Application for Disposal Works Construction Permit

91 STATE STREET, AMHERST, MA

SEPTIC SYSTEM REPLACEMENT PLAN

91 STATE STREET AMHERST, MA

SEPTIC TANK DETAIL

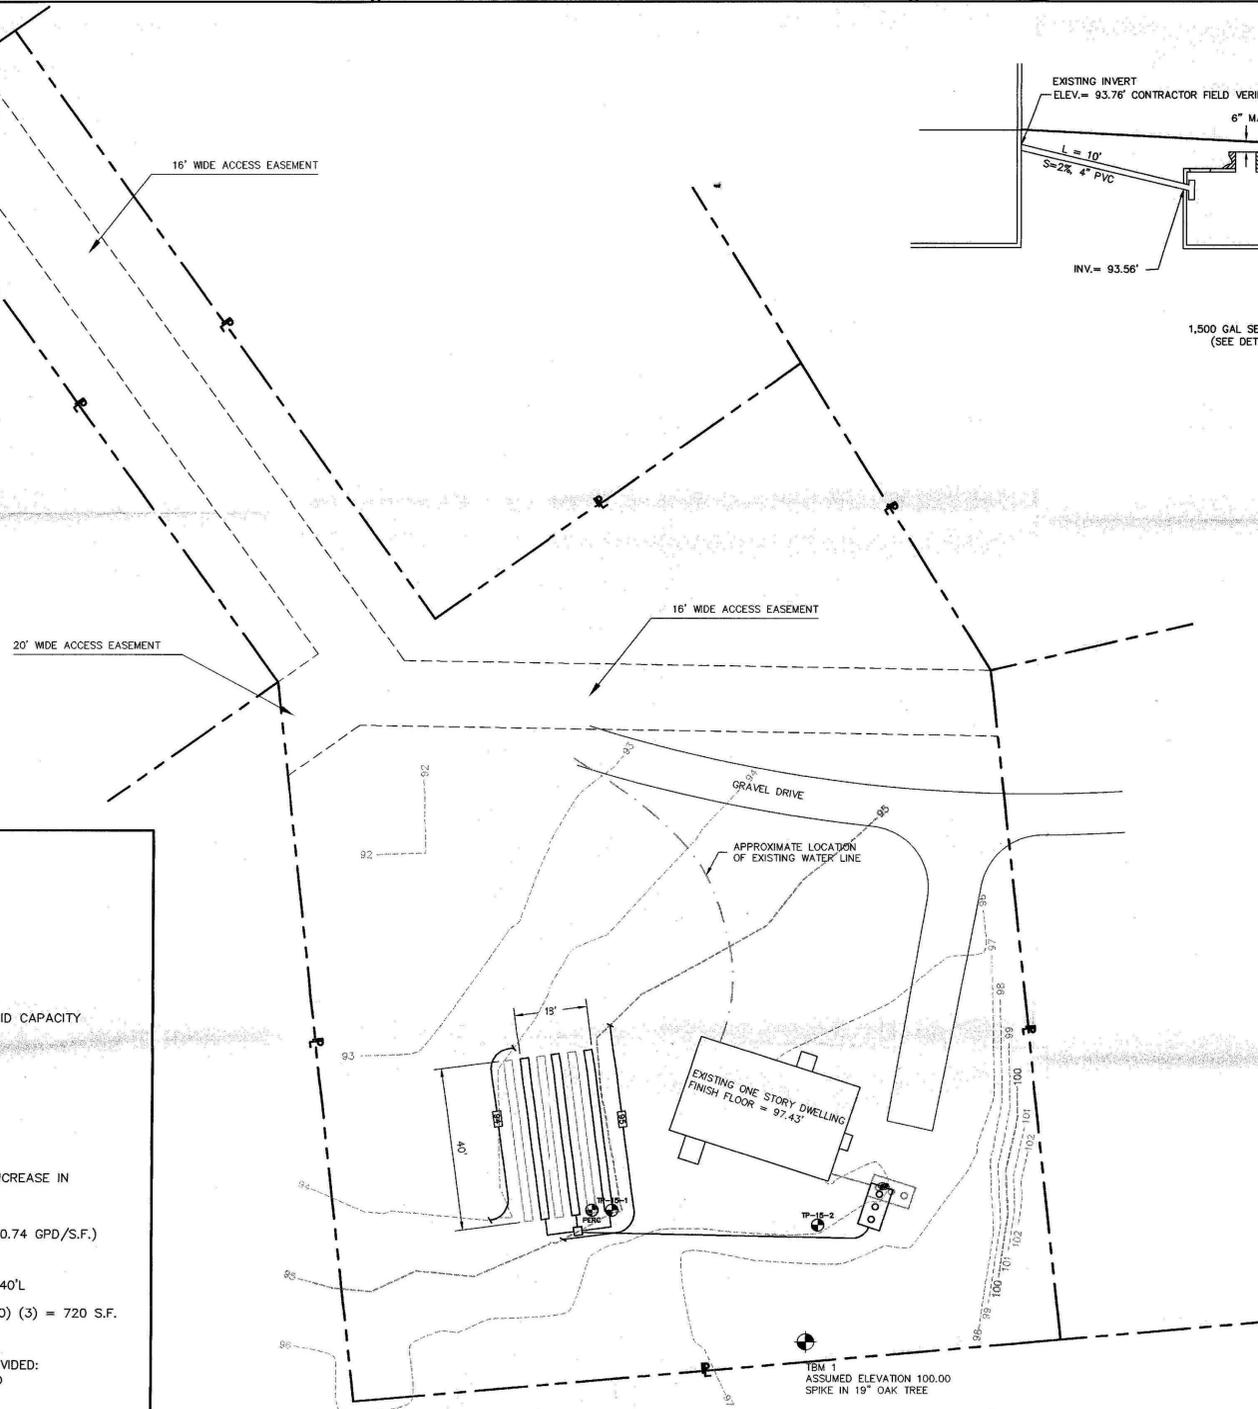
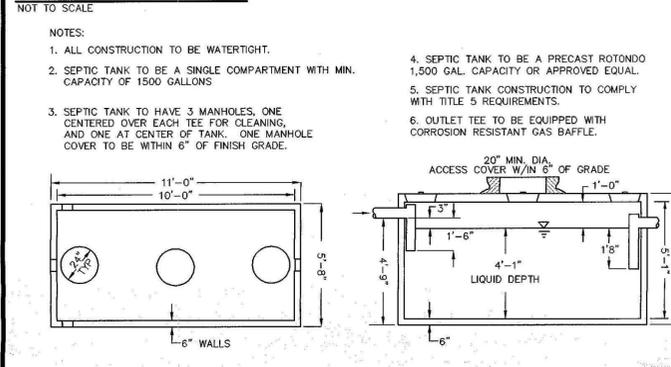
3/6/98/02 Inlet Pipe (from house to tank) must be IN the center of tanks

SEPTIC TANK DETAIL

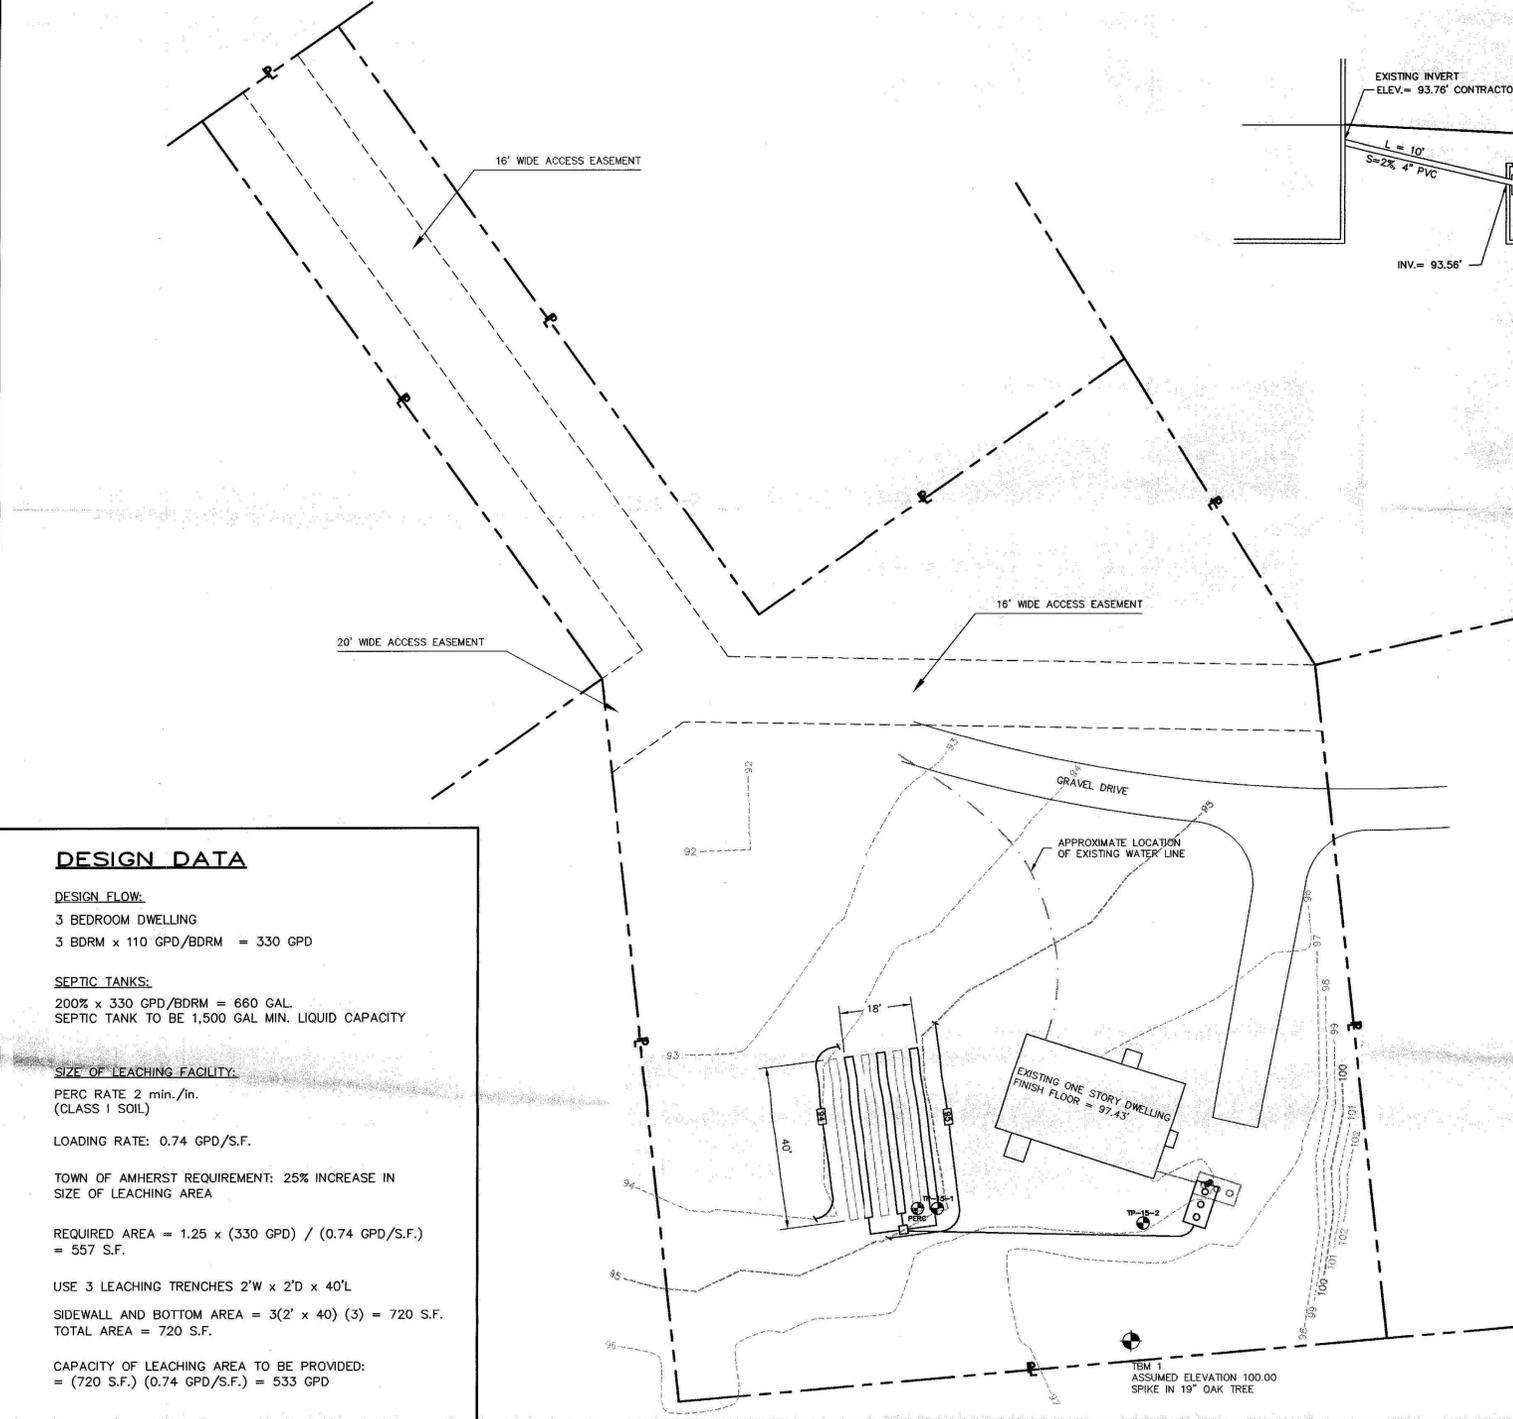
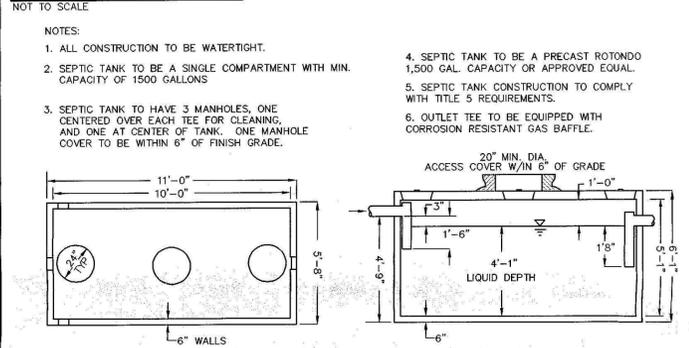
3/4/98 - Inlet Pipe (From house to tank) must be w/ the center line of tank
